July 7, 2021

RE: **Lot 11 Block 9, Volcano Cliffs Unit 22, SAD 228
6405 Petirrojo Rd. NW
2nd Revised Grading and Drainage Plan
Engineers Stamp Date 6/30/2021 (D10D003Q11)**

TITLE: **6405 Petirrojo Rd. NW Grading & Drainage Plan**

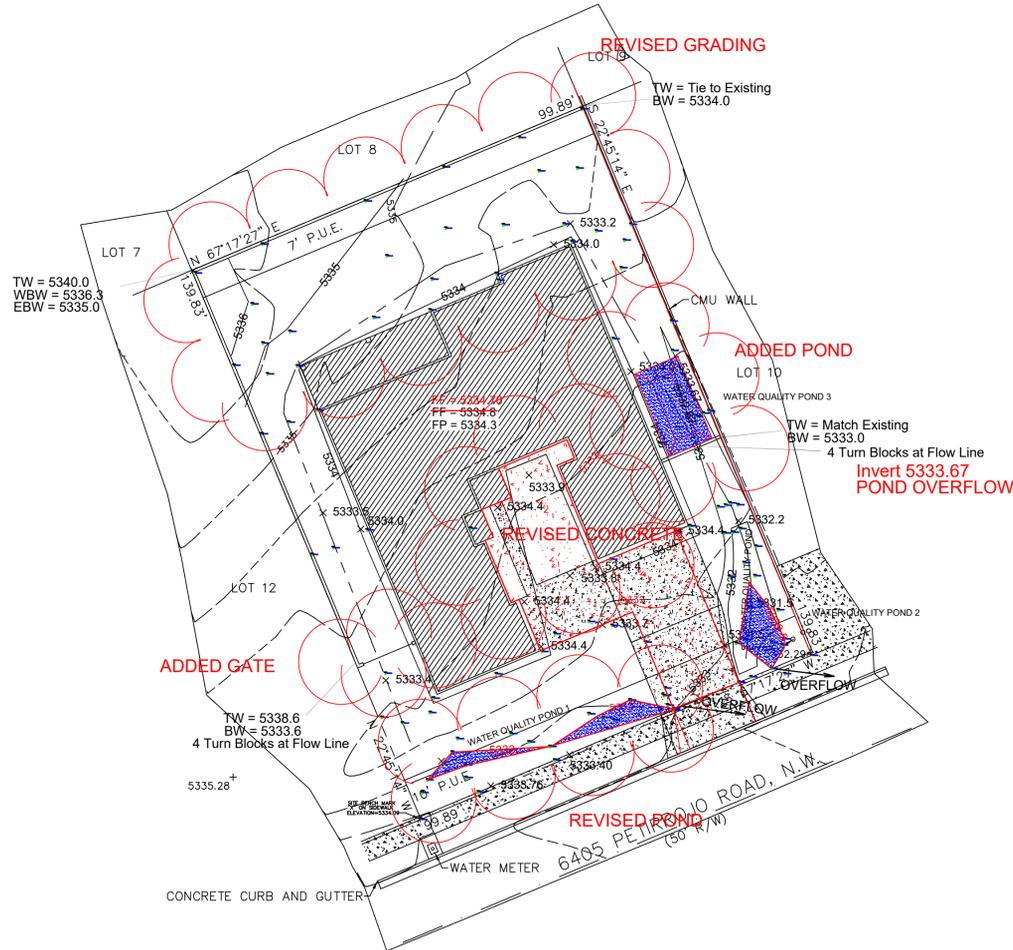
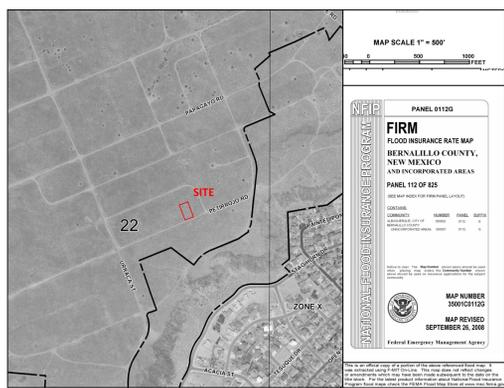
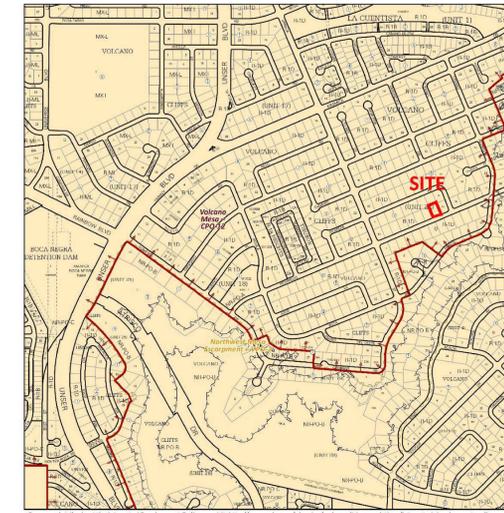
Based upon the information provided in your submittal received 6/30/2021, this plan is approved for Grading Permit.

Prior to Building permit approval a Pad Certification will be required, provided by the Engineer or a registered Land Surveyor.

Reiterate to the Owner/Contractor that a separate permit for a garden/retaining wall must be obtained with the approved G&D plan and Pad Certification.

Prior to Certificate of Occupancy release, Engineer Certification per the DPM checklist is required.
